ELECTRONICS FIELD CHANGE BULLETIN
 NAVAL SHIP ENGINEERING CENTER, NAVY DEPARTMENT
 WASHINGTON, D. C.

23-AN/URC-32
 9-AN/URC-32A
 14-KWT-6(8)

MODIFICATION OF FREQUENCY GENERATOR CV-731/URC
 TO ACCEPT FREQUENCY CONVERTER CV-1749()/UR

PURPOSE: To modify the Frequency Generator CV-731/URC to accept the Frequency Converter CV-1749/UR. This will permit the Radio Set AN/URC-32() to be tuned in .1 KC increments.

FIGURE 7 - CONVERTED FROM FIGURE 1
 AIRMAIL COY-1749 (1/15/40) 2-11

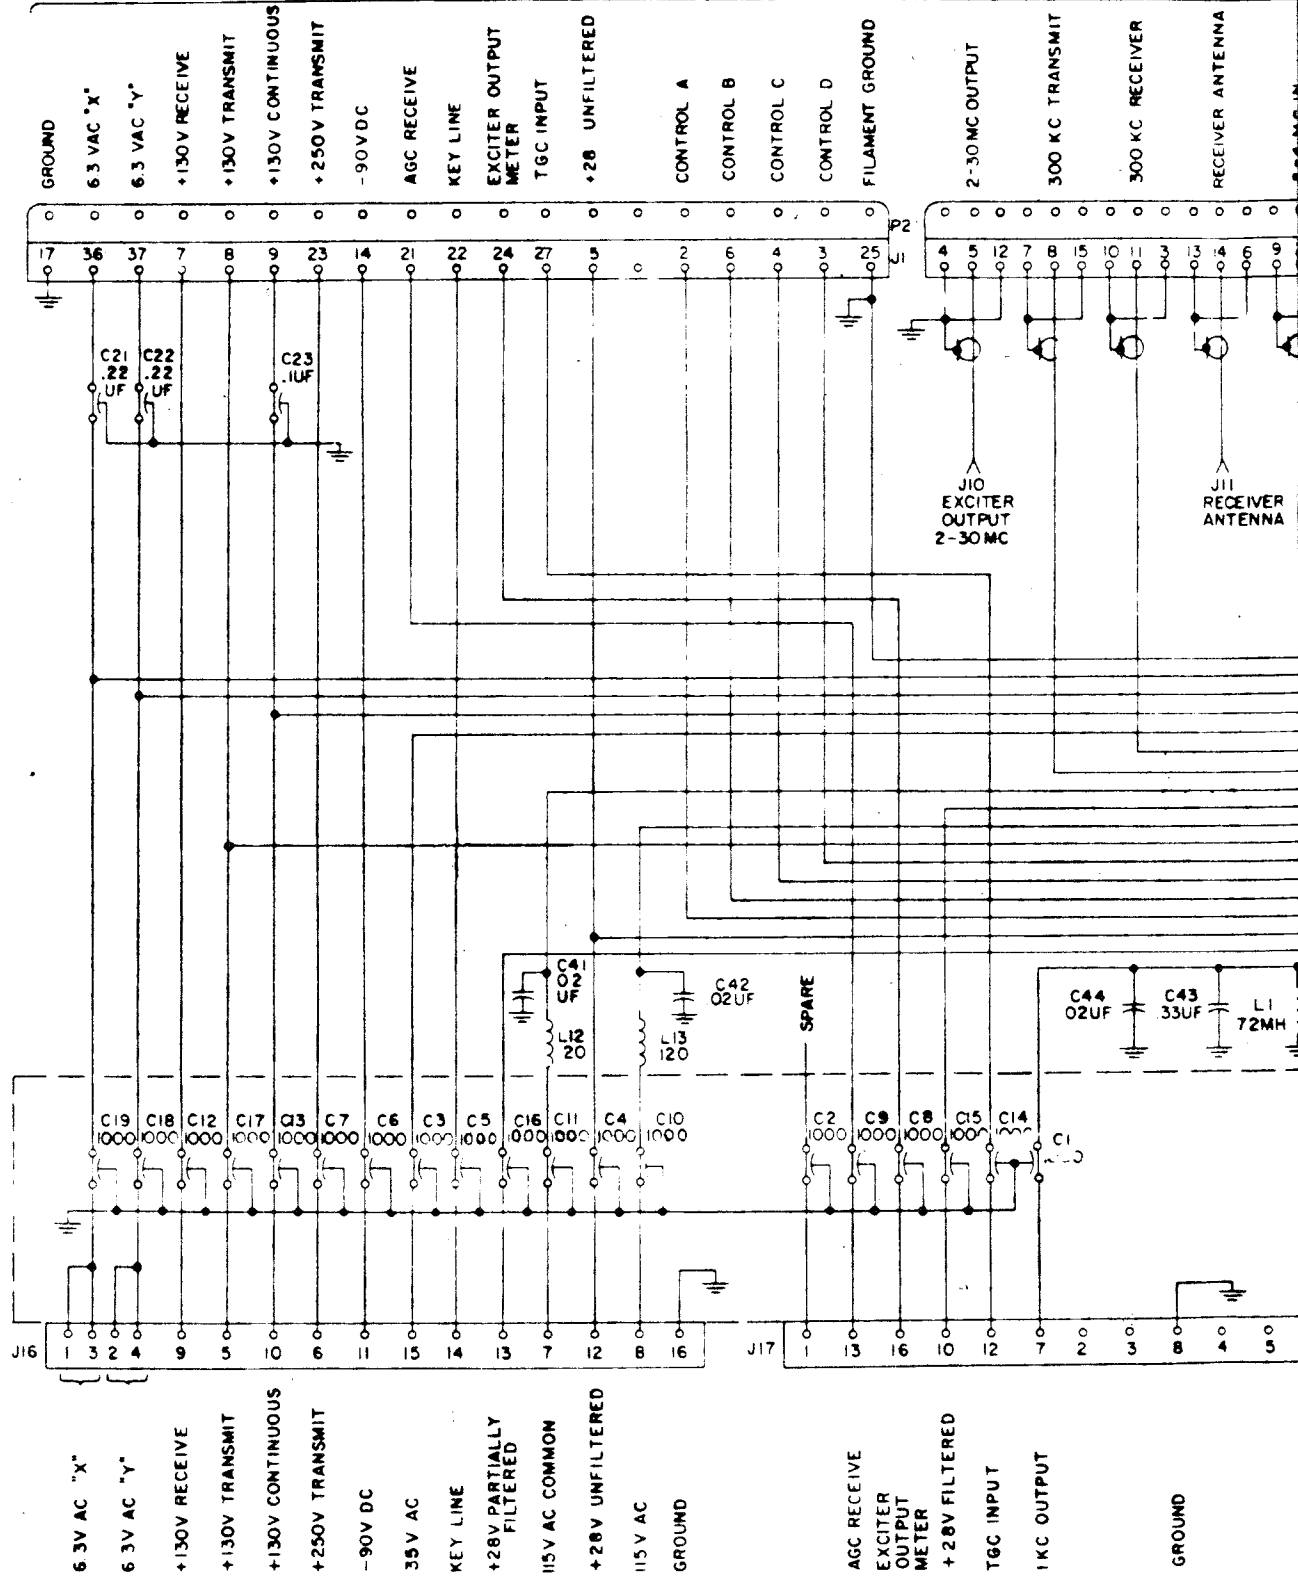
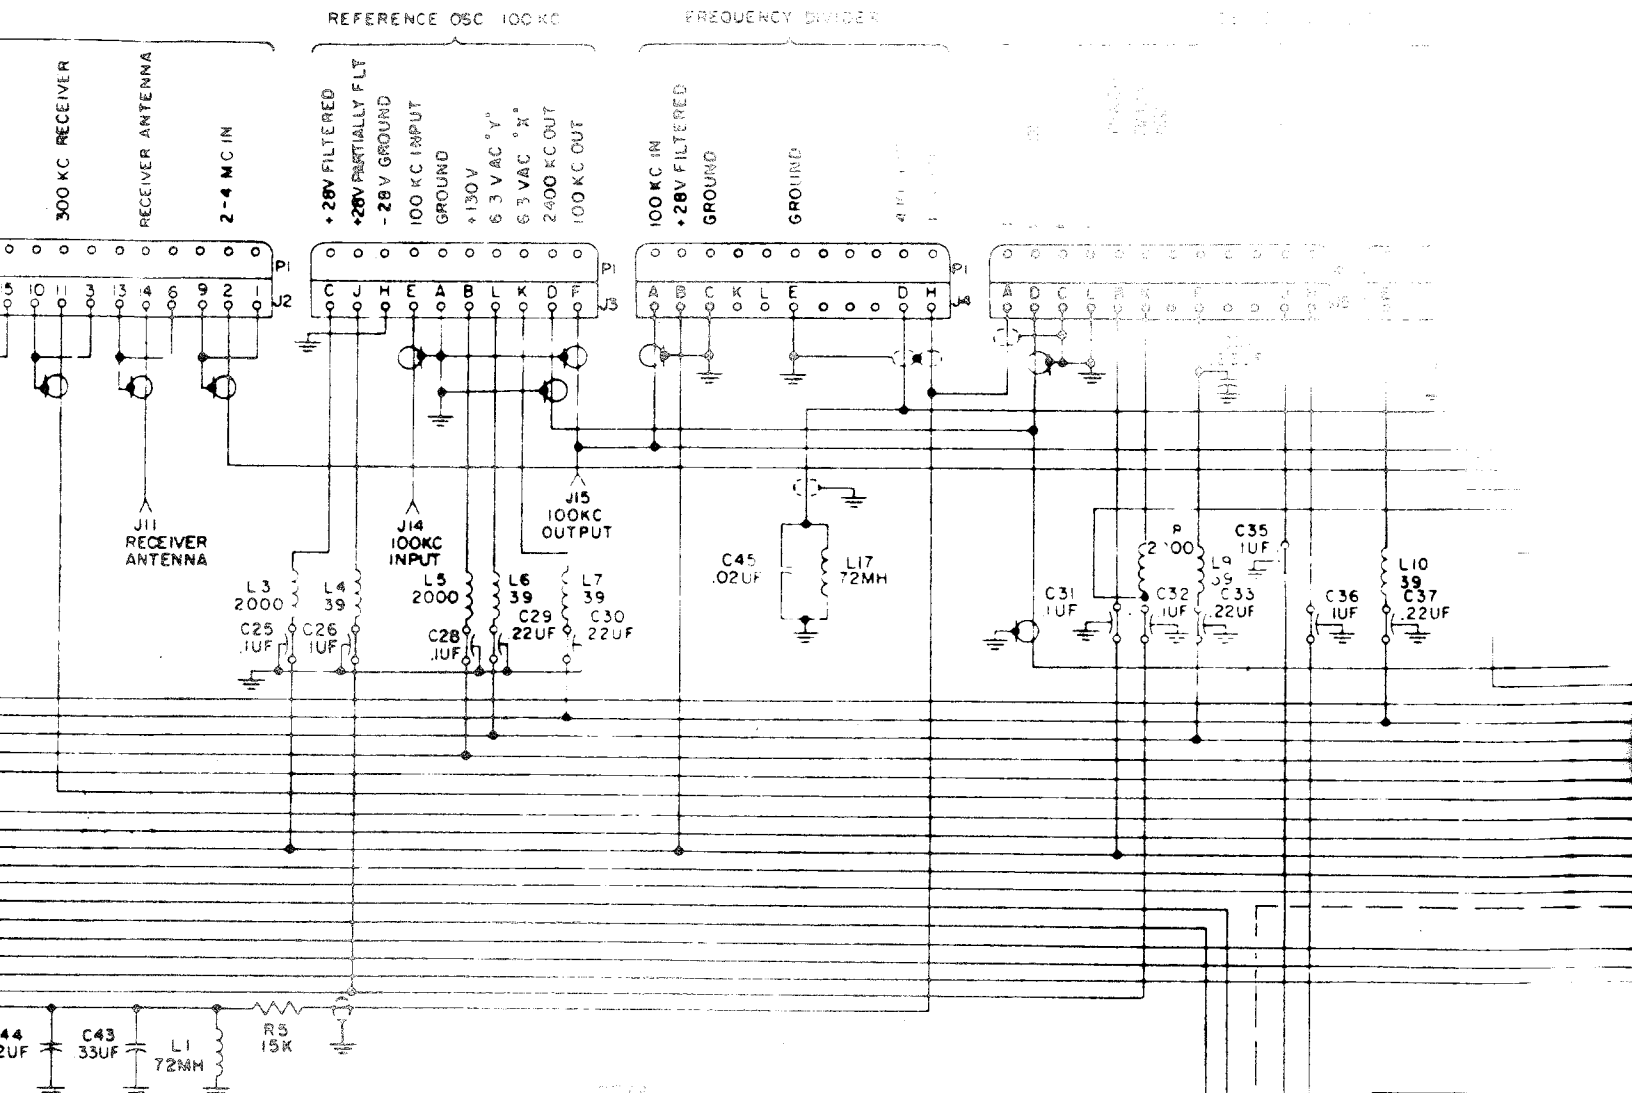
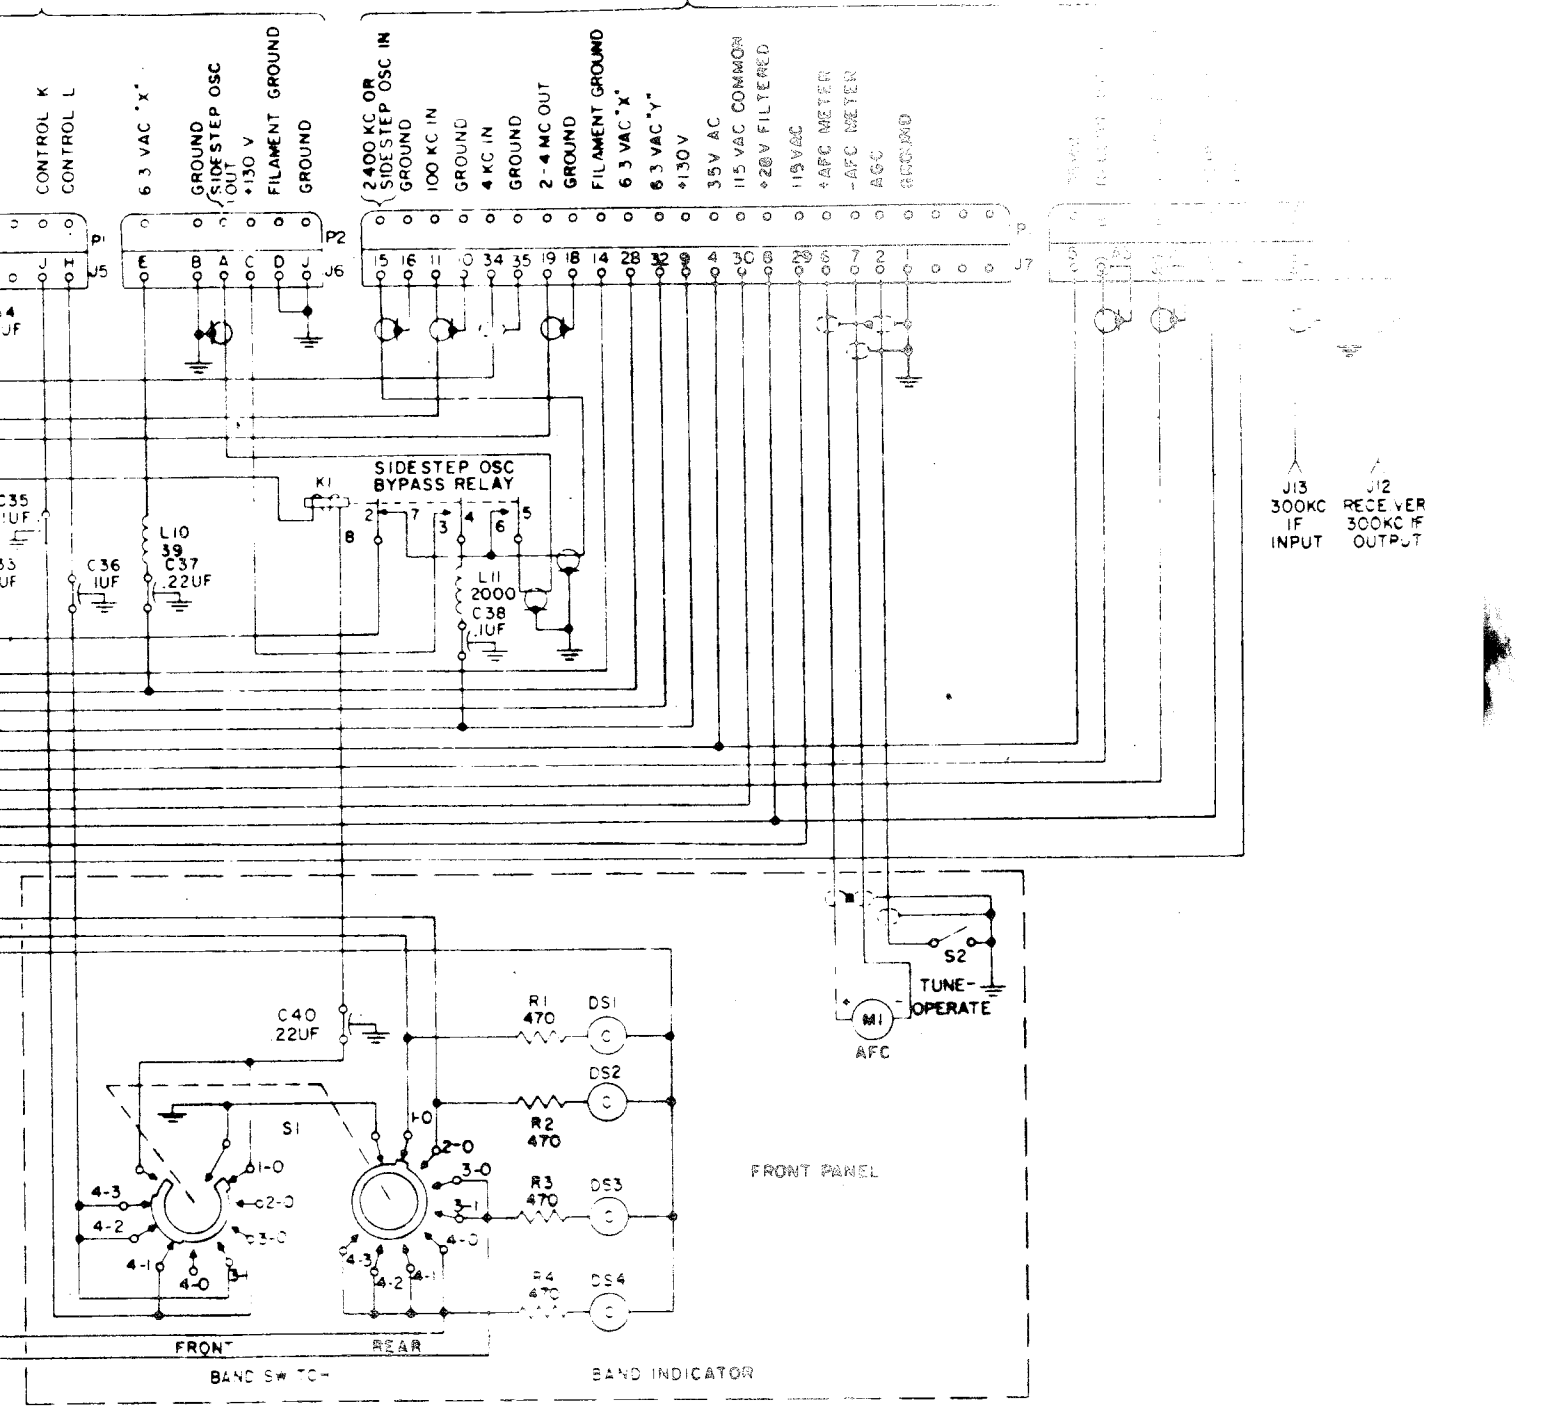
4. Figure 6 is a schematic of CV-1749()/UR. Figure 7 is a schematic of CV-731()/URC after this field change has been completed.

MOD A-ADD WIRE FROM JOINT P15 TO
 JOINT A. MOD B-ADDED C44 AND L17.
